SEWAGE PERMIT APPROVAL

Property Address: 1654 North 2nd Avenue Town Kelso

DATE: 7/22/86
TO: Hamar Construction/ Washington Mutual
FROM: Pedro Pescador Jr., CPSS
SUBJ: SKETCH ONLY- Repair of septic system at 1654 North 2nd Ave., Kelso

Suggested layout of system:

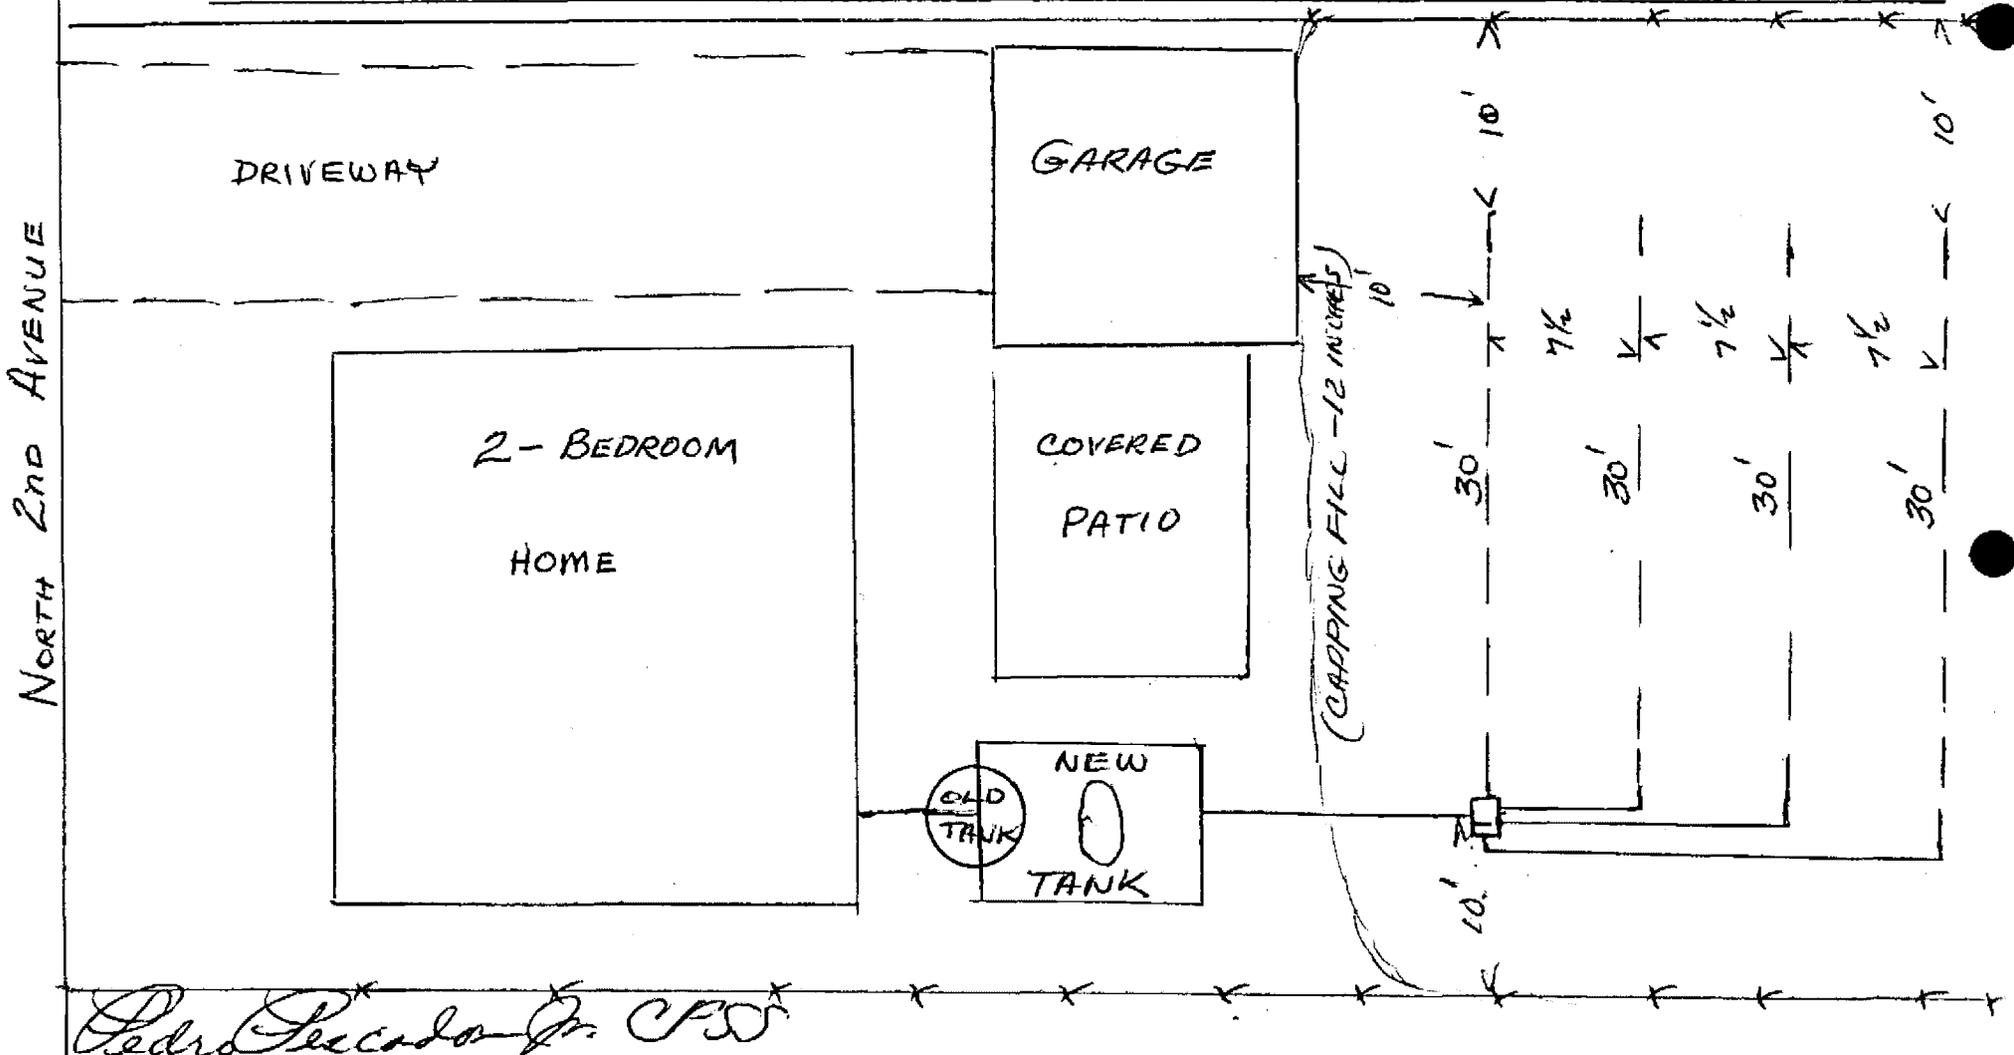
- 1) A 12inch capping fill is needed to assure adequate treatment of the sewage effluent before it reaches the seasonally high water table.
- 2) Maintain 10 feet minimum setbacks from property lines, and buildings.
- 3) Pumped the old steel tank and replace or fill with gravel and cover with soil ; a new septic tank is required .

SOIL DATA:
0-14 Sil
14-54 layers PSL VPSL
MOTTLES FROM 20"
SOME RESIDUAL FROM LANDSCAPE POSITION
5% slope behind GARAGE TOWARD REAR DROP LINE
